Analysis of Matrix Heat Exchanger Performance¹

V. Ahuja² and R. K. Green³. Recently, a new numerical scheme for solving the equations governing matrix heat exchanger thermal performance was published in this journal. It was found that this scheme does not include the full effect of longitudinal heat transfer in the said heat exchangers. This effect is demonstrated by correcting the parameter related to longitudinal heat transfer in the approximate analytical solution for the balanced flow case and finding it to deviate considerably from the numerically calculated result.

Fig. 1 Perforated plate and spacer dimensions

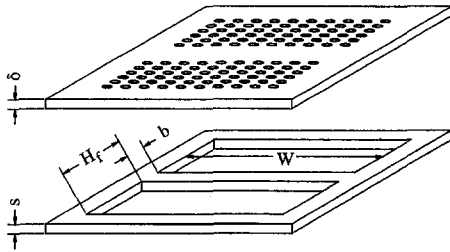
The control volume for which the energy balance is considered for deriving the governing equations does not include the area over which longitudinal conduction occurs other than the separator. The axial conduction parameter defined in Eq. (3) incorporates a spacer area equivalent only to that of the separator (bW). The parameters λ_p and $\lambda_s = n\lambda$ are derived from the energy balance for the separator, for the numerical solution. Venkatarathnam has then applied λ to the approximate analytical solution as the overall axial conduction parameter to account for axial conduction as done by Kroeger (1969). However, Kroeger has used the overall axial conductivity and total area for axial conduction to define this axial conduction parameter λ as

The walls of the perforated plate matrix heat exchanger are formed by bonding a stack of alternating low thermal conductivity (plastic/stainless steel) spacers and copper perforated plates to form a monolithic block (Fig. 1). The walls that separate the streams from the environment and that which separate the two streams are thus interconnected. In deriving the governing equations, it was assumed that the longitudinal heat conduction occurs only through the walls that separate the streams, to simplify the analysis. This assumption has been made by many workers (Kroeger, 1967) who have studied the performance degradation due to longitudinal heat conduction through the walls of heat exchangers. These assumptions are meant only to simplify the analysis and make the problem tractable. While analyzing the performance of any real heat exchanger it is necessary to take the longitudinal heat conduction through all the walls. In most cases, the performance of the heat exchanger will be slightly underpredicted if the longitudinal heat conduction through the outer walls is accounted for by adding the cross-sectional areas of the outer and inner walls, and assuming that all the longitudinal heat conduction occurs only through the inner wall alone (Narayanan, 1997).

It is well known that the longitudinal heat conduction parameter should be estimated using the area of all the walls of any exchanger, including perforated plate matrix heat exchangers. To demonstrate the basic principles of heat exchangers, Mills (1996) used the total foot print area to evaluate the longitudinal heat conduction parameter and predict the performance degradation due to longitudinal heat conduction in perforated plate heat exchangers. Thus, the suggestion made by Ahuja is not new.

Fig. 2 Ntu_{eff} versus Ntu_D for a: Venkatarathnam, analytical; b: Venkatarathnam, numerical; c: analytical, using λ from (8); d: numerical, using λ from (8); e: analytical solution using Fleming's (1969) equation for fin effectiveness and Kroeger's method for longitudinal conduction

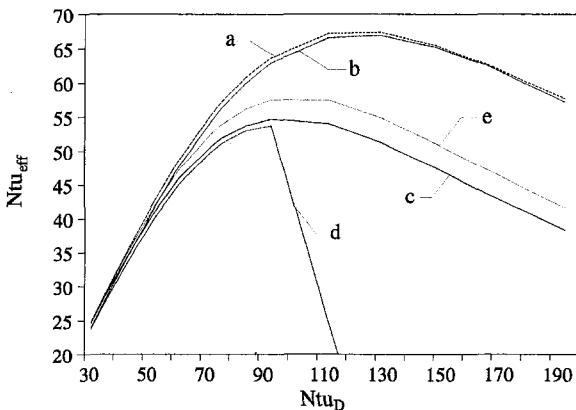
Venkatarathnam's use of λ thus represents a small proportion of the area over which axial conduction occurs, and the net axial conductivity. The effect of taking λ from (3) or (8) is shown in Fig. 2.

Venkatarathnam's results were presented as Ntu_{eff} versus Ntu_D graphs for constant ϕ and λ . A matrix heat exchanger of given geometry at one flow condition would represent a single point on such a graph. Figure 2 shows Ntu_{eff} versus Ntu_D plotted for given constant geometric parameters. Venkatarathnam's ap-

proximate analytical and numerical solutions only show agreement provided λ is calculated for the separator alone. If λ is taken as the overall axial conduction parameter, the approximate analytical solution deviates considerably from the numerical solution. As to whether the numerical solution can take into account axial conduction in the heat exchanger body other than in the separator is uncertain.

Fig. 3 Ntu_{eff} versus Ntu_D for a: Venkatarathnam, analytical with $\lambda_p = \infty$; b: this work, with finite values for λ_p ; c: Venkatarathnam, numerical; d: analytical solution using Fleming's equation for fin effectiveness and Kroeger's method for longitudinal conduction

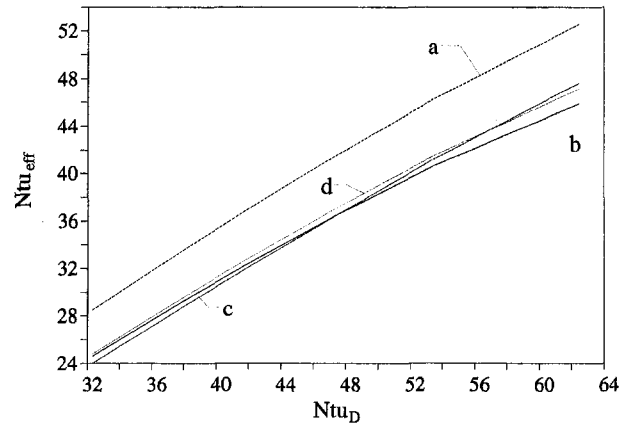
The effect of taking $\lambda_p = \infty$ is shown in Fig. 3. The convection heat transfer coefficients for the matrix heat exchanger are much higher than those normally associated with gaseous heat transfer media. It is apparent that the simplification of $\lambda_p = \infty$ may not

be justifiable for the low Reynolds number flows which are characteristic of matrix heat exchangers.
